## DESCRIPTIVE REPORT

*Type of Survey* ..... HYDROGRAPHIC

*Registry No.* ..... H11732

*Sublocality* ..... Black Point to Fort Ross Cove

**Figure 2 Uncertainty DTM**

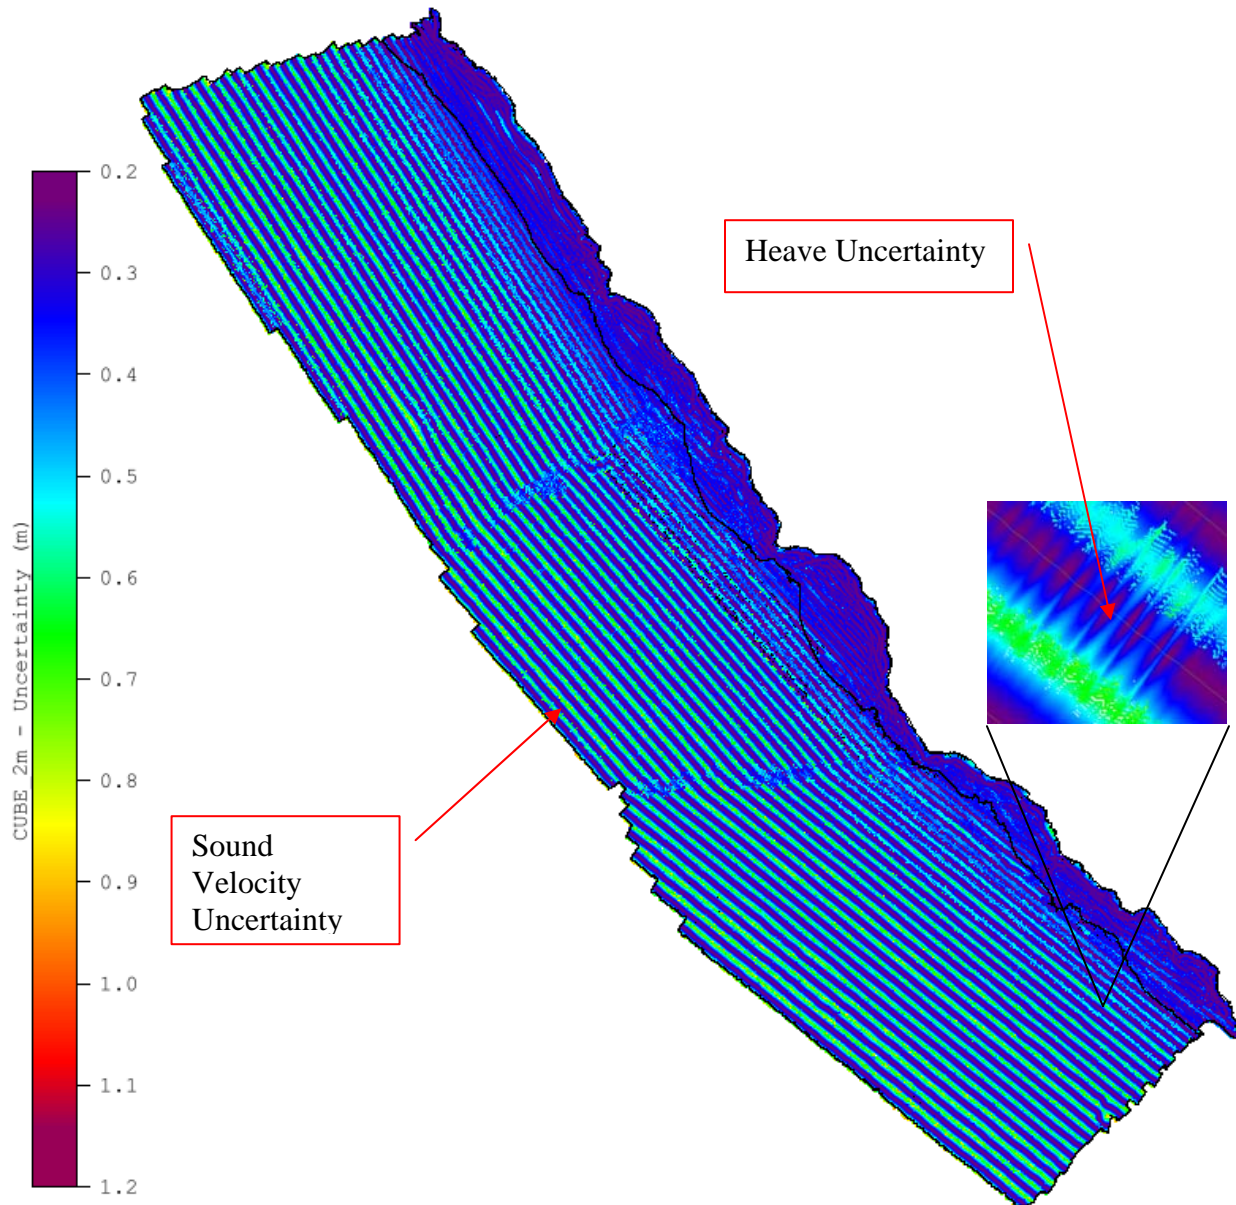
The majority of H11732 had uncertainty values of 0.30 m to 0.60 m, with extremes of 0.23 m and 1.14 m. The effects of speed sound uncertainty are very apparent in the graphic below. No uncertainty values exceeded IHO Order 1.<sup>4</sup>

<sup>4</sup> Concur.

**Figure 3 H11732 Survey Junctions**

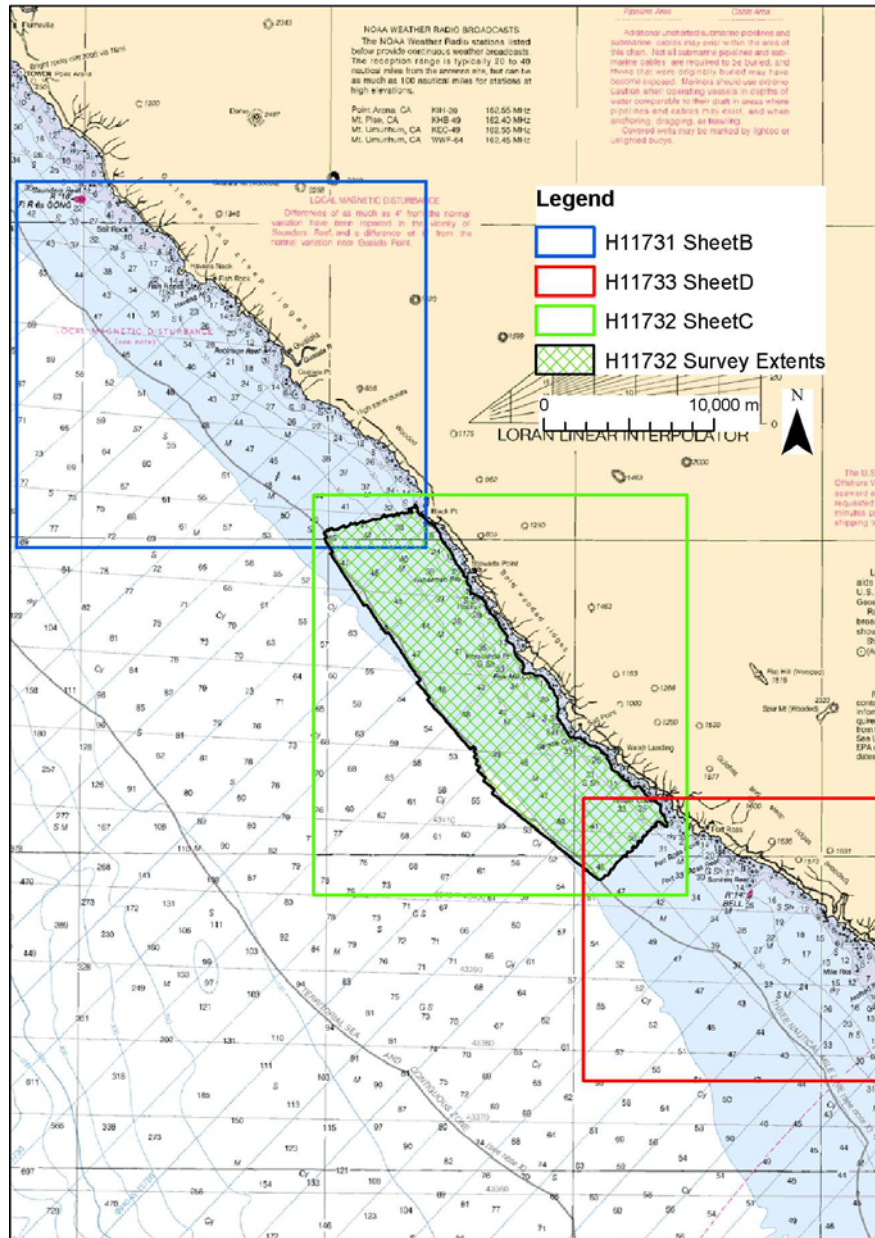
The surveys are in agreement along their common borders. The agreement was noted in the field using the CUBE surfaces during subset cleaning. The conformity is also apparent in the Final Combined BASE Surfaces.<sup>5</sup>

<sup>5</sup> Concur.
